TITLE	DWG. NO.	REV.	APV
2019 MADP	VI3000387	E	--
44" ELECTRIC EXP F2F DINETTE	DR A.CERVANTES	DATE 09.08.17	--
THIS DRAWING IS THE PROPERTY OF VILLA INTERNATIONAL MFG. ALL RIGHTS RESERVED.

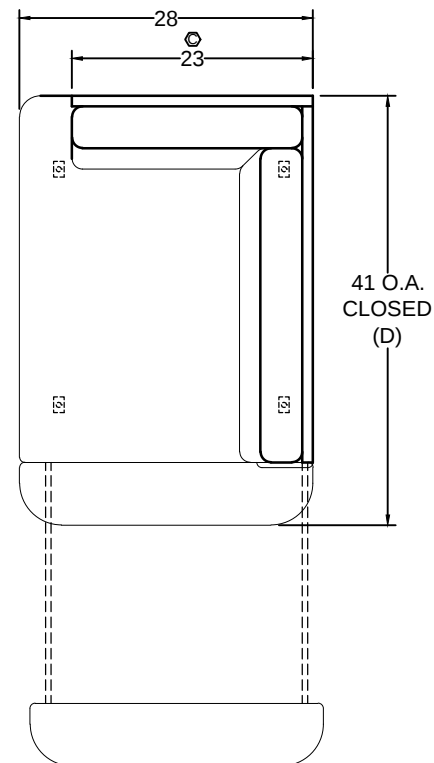
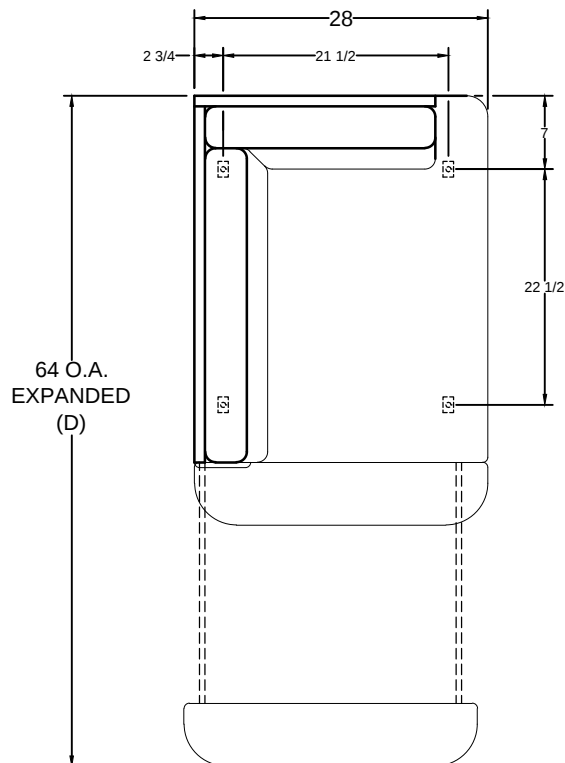
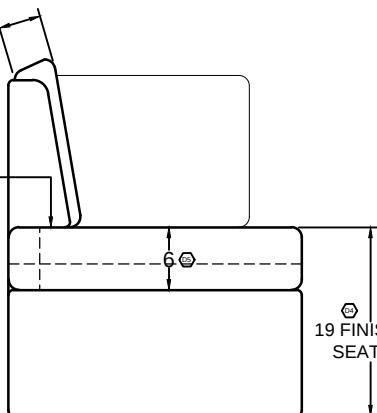
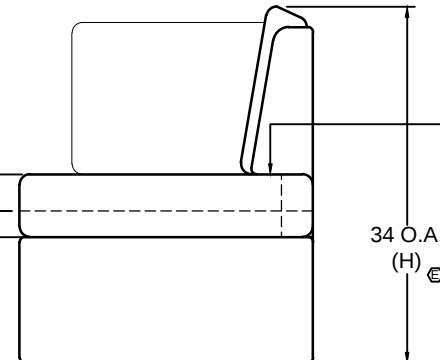
LB	E	CHANGED OVERALL HEIGHT TO 34"; WAS 35 1/2". (REF. ECO #109-2019)	10.07.19
AC	D	PER RL: [1] MODIFIED DIMENSION. [2] ADDED LEG HEIGHT DIMENSION. [3] ADDED SEAT FOAM THICKNESS. [4] ADDED FINISHED SEAT HEIGHT. [5] ADDED FINISHED SEAT THICKNESS.	09.21.18
AC	C	DRAWING CORRECTION: CORRECTED ARM DEPTH TO BE 23", PER ORDER.	09.12.18
JA	B	PRODUCTION UPDATE: CHANGED TOE KICK TO 3" BAND.	08.14.18
JA	A	PRODUCTION UPDATE: DELETE PULL FROM SEAT CUSHIONS.	08.03.18
